## GENERAL SERVICE BULLETIN

### Additional information for camshaft carrier and timing chain replacement - 1.5L EcoBlue engine

**23-7029**

04 May 2023

### Camshaft carrier and timing chain

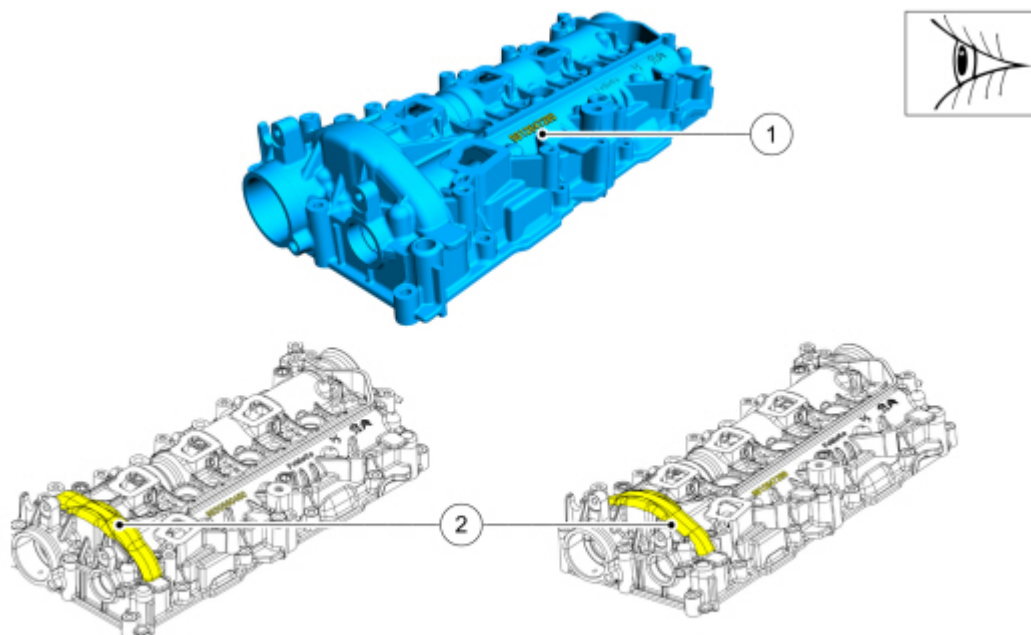
Old and new camshaft carrier can be indentified by reading the number or the shape.

Part number marking on the upper camshaft carrier

Item	Description
1	Location of the part number marking on the upper camshaft carrier
2	7 mm configuration : 9812647280 / 8 mm configuration : 9830580480

Lower injector foam. Part Number: L1BQ-9U550-CA; Finis Code: 2 644 856

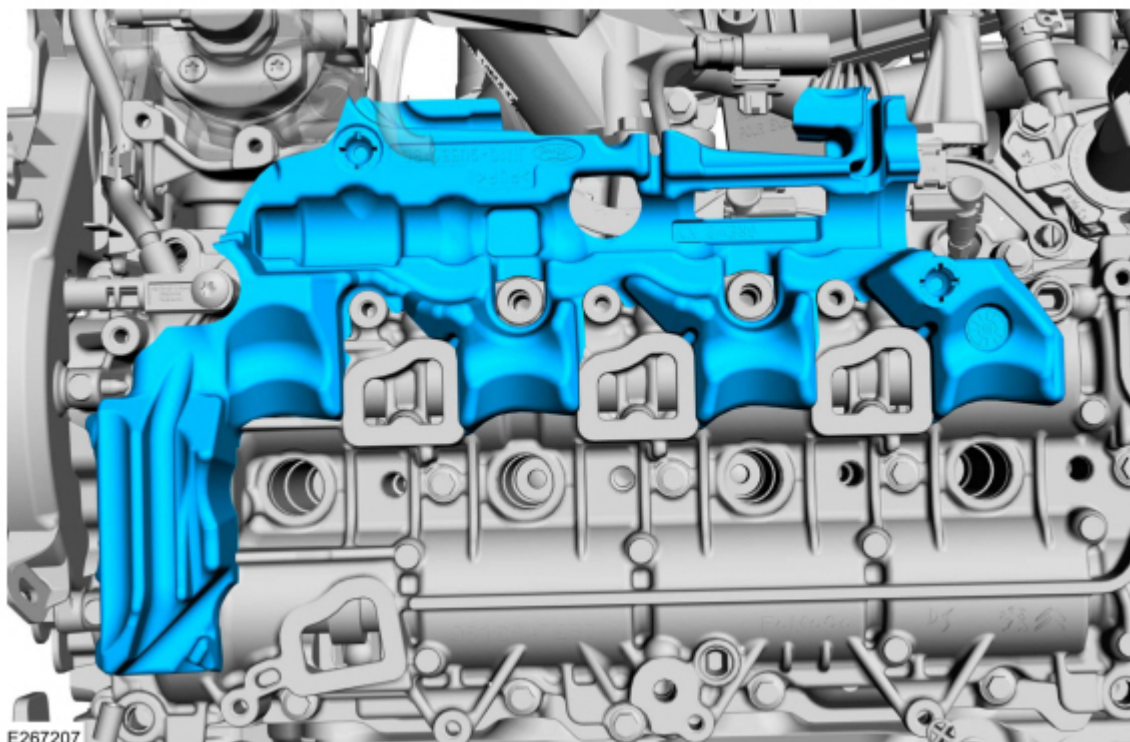
The table attached to this Service Information shows the old / new part numbers for the camshaft carrier. When exchanging a camshaft carrier by the new design instead of old design, also the lower injector foam needs to be replaced as well.

In case of camshaft chain or tensioner failure with damage to valves and pistons, the 8 mm timing chain pitch service engine (including the 8 mm camshaft carrier assembly and the 8 mm injector noise dampening foam) must be installed.
